COMMONWEALTH OF KENTUCKY
BEFORE THE KENTUCKY STATE BOARD ON ELECTRIC GENERATION
AND TRANSMISSION SITING

Electronic Application of Caldwell Solar, LLC)
for Certificate of Construction for an up to 200)
Megawatt Merchant Electric Solar Generating)
Facility in Caldwell County, Kentucky)

Case No.
2020-00244

Response to Siting Board Staff's Second Request for Information

Figure 2 ESB 12- Bridge Data
 Caldwell Solar Project
 Caldwell County, Kentucky

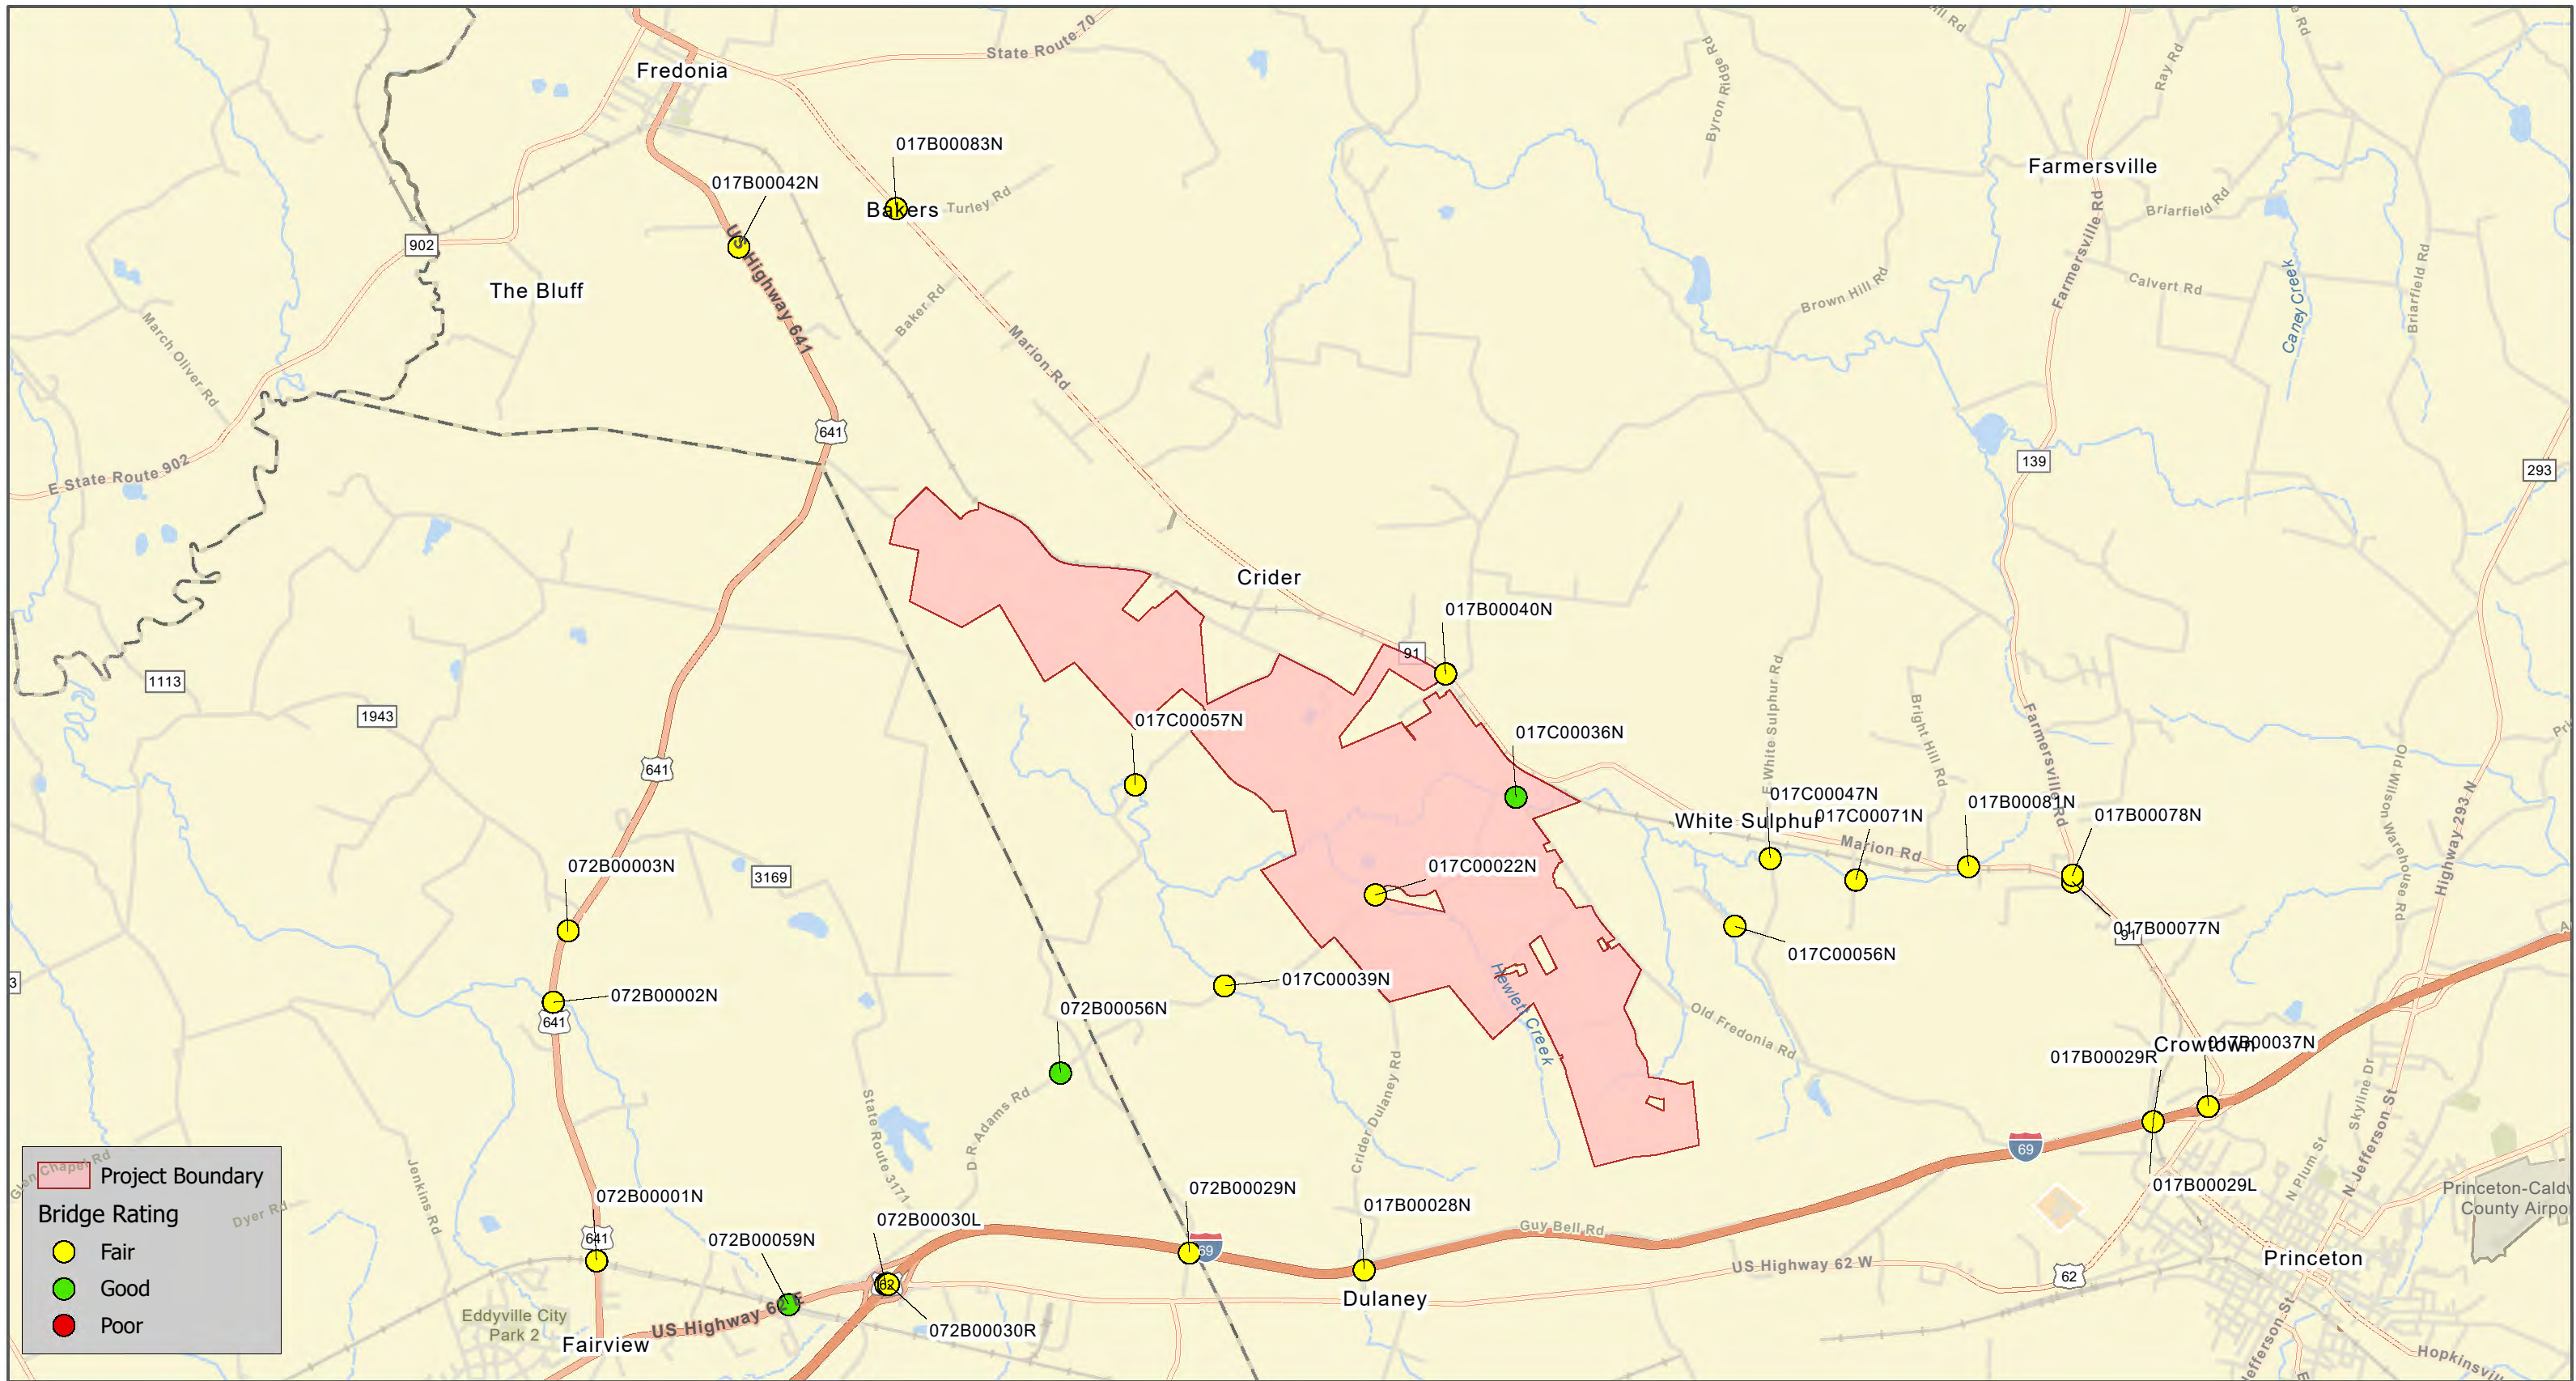
12. Refer to Caldwell Solar's response to Staff's First Request, Item 54(b). According to the Kentucky Transportation Cabinet's Bridge Data Miner map, it appears that as many as 12 bridges in the area could be used in order to access the Project site.
 - a. Provide a list of all the bridges in the Project area (by numerical identification number and location) that could potentially be used by Project construction or operational vehicles.
 - b. Provide the bridge weight limit for each of the bridges listed.
 - c. Explain whether overweight vehicles will access the Project site using any of the bridges listed.
 - d. Describe the plans to avoid or improve or mitigate damage to any of the bridges listed to accommodate overweight vehicles.
-

- a. Caldwell Solar has not finalized the construction or operation transportation routes at this time and cannot confirm what bridges will be utilized by the Project. For the purposes of this data request, Caldwell Solar has included a list and map of bridges near the Project site that fall within the triangle created by the three main highways surrounding the Project site (KY-91, US 641, I-69). See Figure 2 ESB 12- Bridge Data attached hereto.

- b. See Figure 2 ESB 12- Bridge Data.
- c. Overweight vehicles may need to access the Project site using some of the identified bridges. If overweight vehicles need to cross a bridge, Caldwell Solar will obtain and be in compliance with all necessary permits from the applicable road authority.

- d. Caldwell Solar will obtain and be in compliance with all necessary permits from the applicable road authority. Caldwell Solar will coordinate any required mitigation with the applicable road authority.

Caldwell Solar Visual Rendering Spots

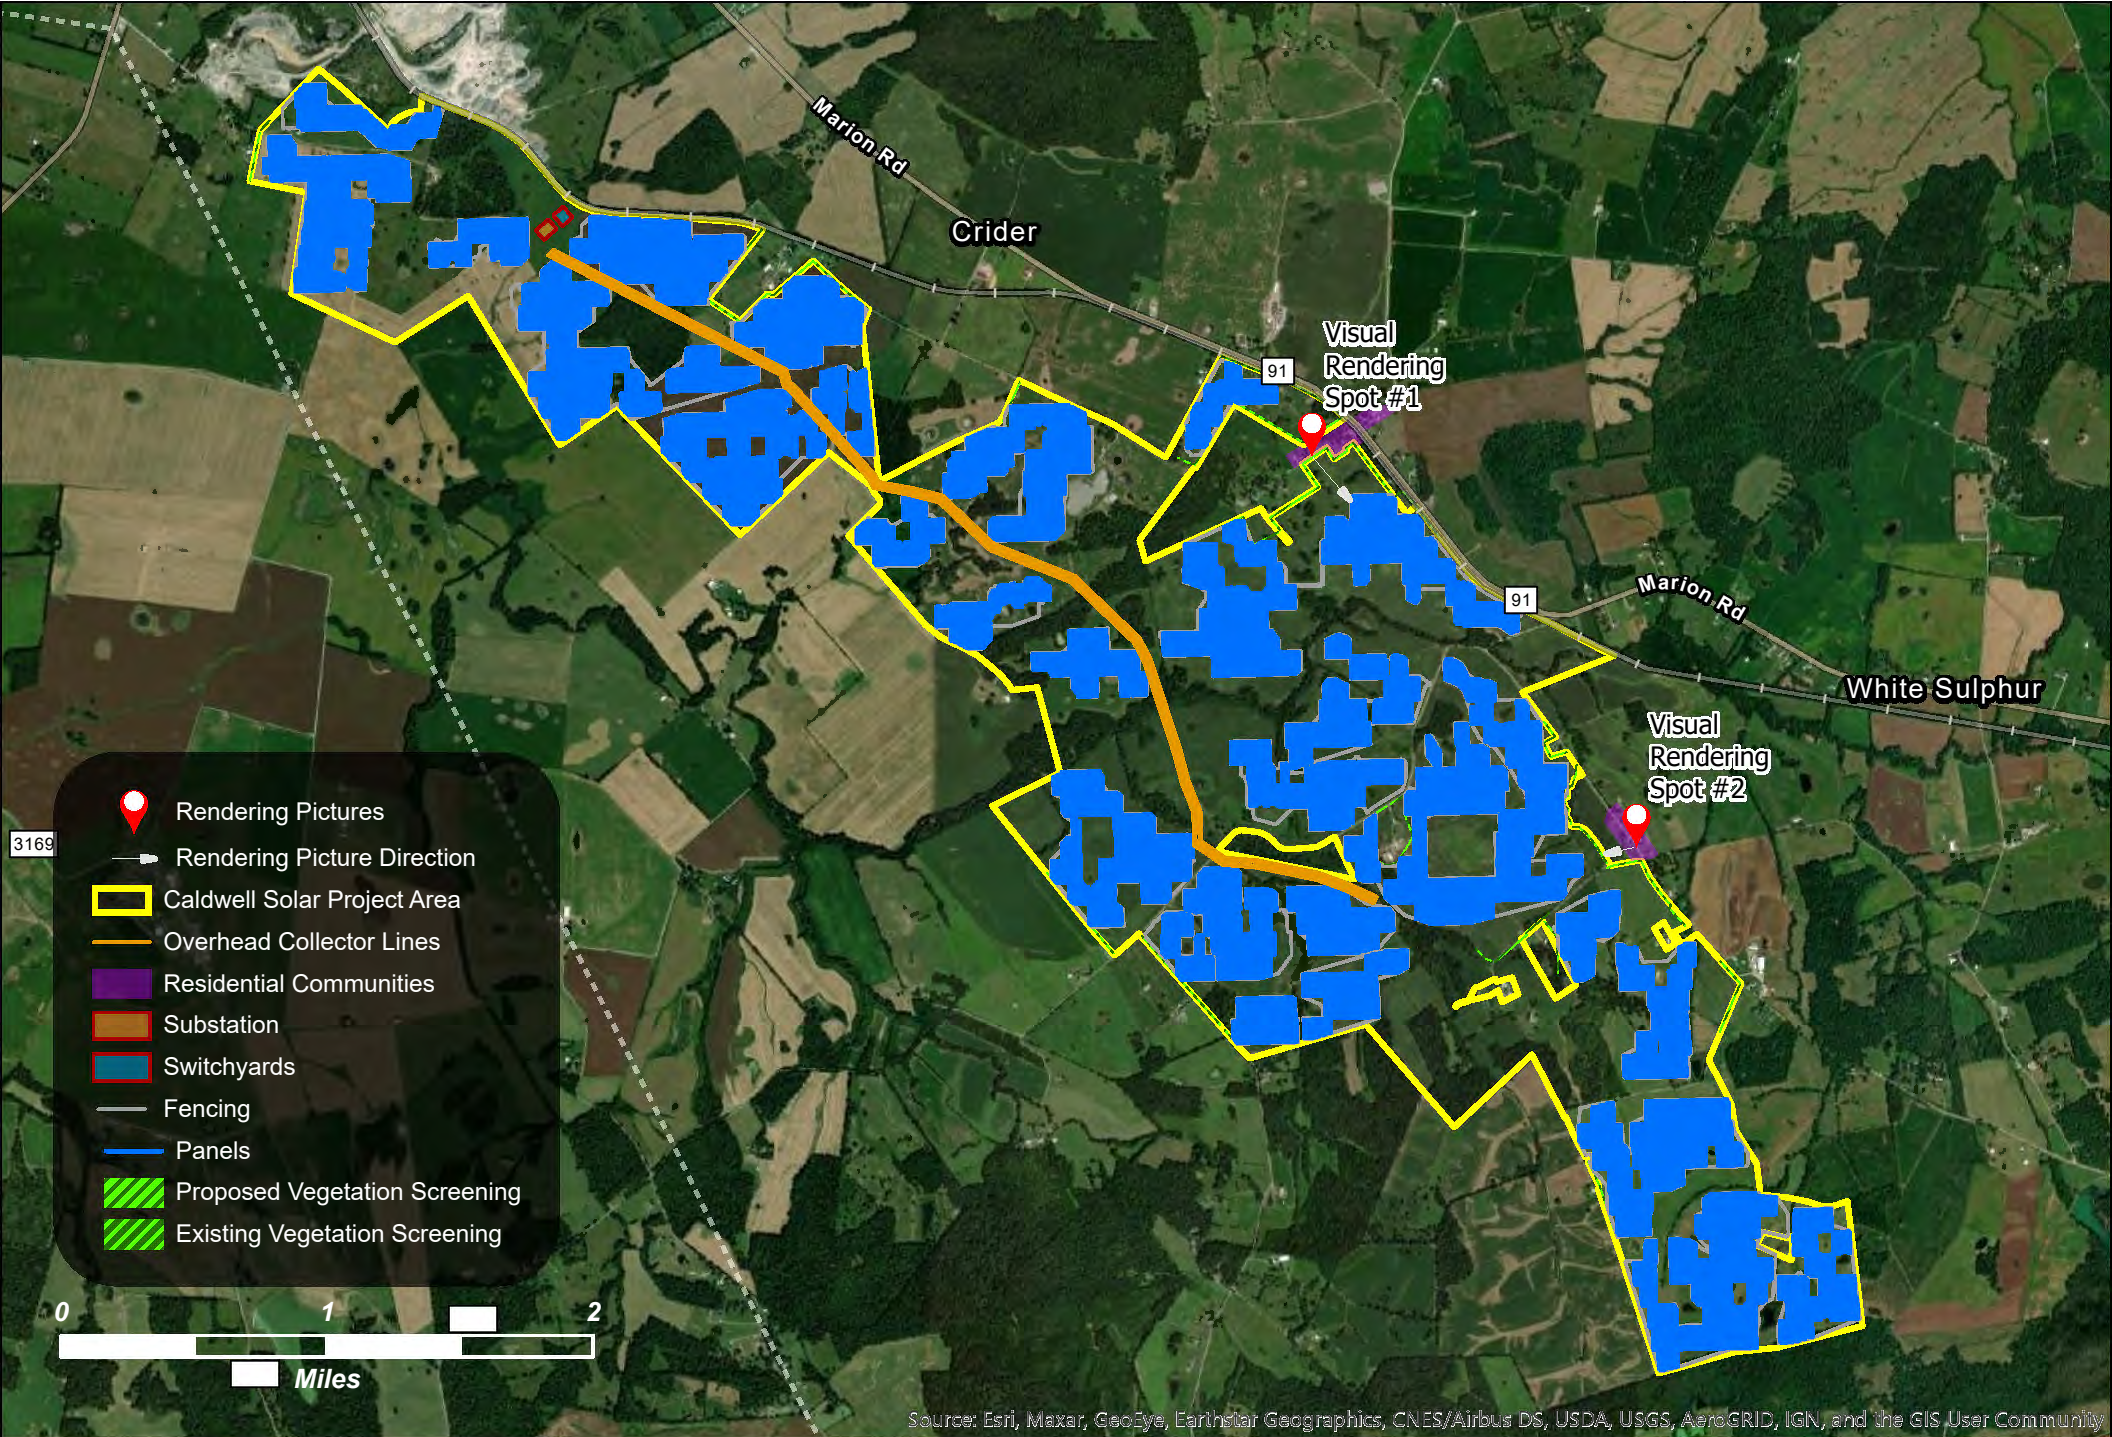
29. Refer to Caldwell Solar's response to Staff's First Request, Items 72(h) and (i). Provide the visual renderings noted.

The visual renderings are attached hereto as Figure 2 ESB 29 Visual Renderings.

Visual Rendering Spot 1 shows the view at the residential cluster off Crider Road facing southeast towards the Project site. Visual Rendering Spot 1 includes renderings of the proposed solar panels, the existing vegetation, and the proposed new vegetation buffer at year 1, year 5-7, and maturity.

Visual Rendering Spot 2 was taken at the residential cluster off Old Fredonia Road facing southwest towards the Project site. Visual Rendering Spot 2 shows the proposed solar panels and existing vegetation buffer. Since the vegetation is already existing and new vegetation is not proposed, only one rendering was needed at this spot.

Figure 2 Route 91, Route 641 and Interstate 69 Roadway Segments Analyzed in GlareGauge

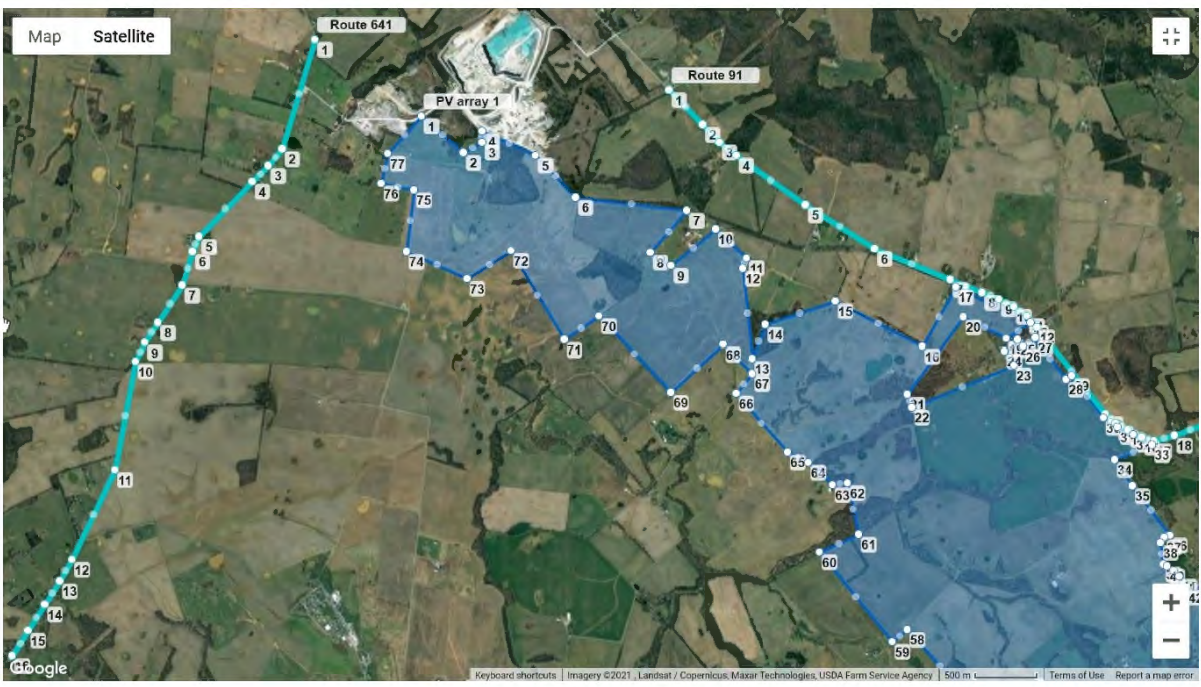
30. Refer to Caldwell Solar's response to Staff's First Request, Item 73. Explain the potential for glare to affect adjacent or nearby residences and confirm that glare may potentially affect adjacent residences or provide additional analyses addressing glare for nearby residences.

For the roadway analysis, the closest nearby main roadway of Route 91 which runs essentially southeast-northwest, Route 641 which runs northeast-southwest and Interstate 69 which essentially runs east-west were analyzed as they traverse near the project boundaries. **Figure 2** shows the Project array boundaries and roadway segment locations from the GlareGauge model selected for analysis, while **Figure 3** shows only the array boundaries as input into GlareGauge for the northern and southern portions of the project, respectively while **Figure 4** shows the array boundaries with the residence receptor locations as input into GlareGauge for the northern, central and southern portions of the project, respectively.

The roadway segments are depicted in light green/blue (teal) in **Figure 2** while the residence locations are depicted as red OP circle in **Figure 4**.
